Access Compliance Report

Public Rights-of-Way

(Curb Ramps)

Intersection ID: 14530	Main Street: E_5TH_ST	Cross Street: N_LAUREL_AV	Location: W
ADA ID: C2E4CEE98574	Ramp Type: Perp	Initial Pass/Fail: Fail	Overall Compliance: No
			Severity Score: 21.25

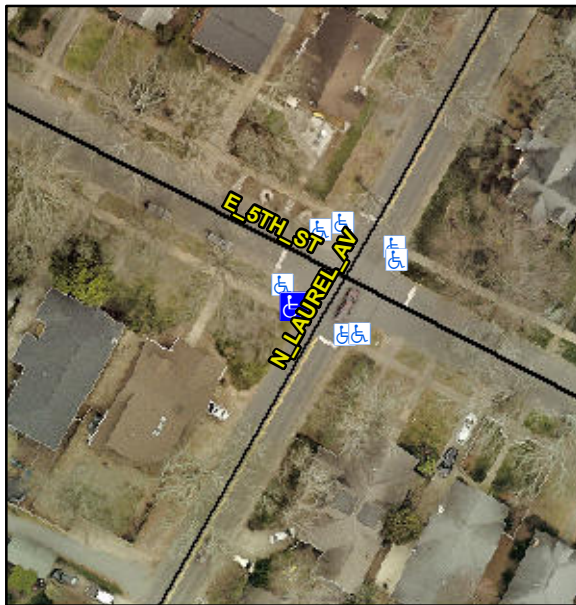
R304.5.1, R304.2.2

Compliance	Description	Data	Compliance	Description	Data
N/A	Ramp Length (in)	54.0	No	Ramp Slope (%)	10.5
No	Ramp Width (in)	41.0	Yes	Ramp XSlope (%)	2.0
N/A	Flare Type LT	N/A	N/A	Flare Type RT	N/A
N/A	Flare Slope LT (%)	N/A	N/A	Flare Slope RT (%)	N/A
N/A	Flare Traversable LT?	N/A	N/A	Flare Traversable RT?	N/A
N/A	Landing Length (in)	N/A	N/A	DWS Provided?	N/A
N/A	Landing Width (in)	N/A	N/A	DWS Contrast?	N/A
N/A	Landing Slope (%)	N/A	N/A	DWS Length (in)	N/A
N/A	Landing X Slope (%)	N/A	N/A	DWS Full Width?	N/A
N/A	Landing Curb? (Y/N)	N/A	N/A	DWS Offset (in)	N/A
N/A	Shared Landing?	N/A			
N/A	Gutter Ponding?	N/A	N/A	Gutter Slope (%)	N/A
N/A	Gutter Lip Ht (in)	N/A	N/A	Gutter X Slope (%)	N/A
N/A	Painted X Walk1?	No	N/A	Painted X Walk2?	N/A
	X Walk 1 Direction	To SE		X Walk 2 Direction	N/A
N/A	X Walk 1 Width (in)	N/A	N/A	X Walk 2 Width (in)	N/A
	X Walk 1 Slope (%)	0.4		X Walk 2 Slope (%)	N/A
	X Walk 1 X Slope (%)	3.7		X Walk 2 X Slope (%)	N/A

Remove & Replace Entire Ramp.
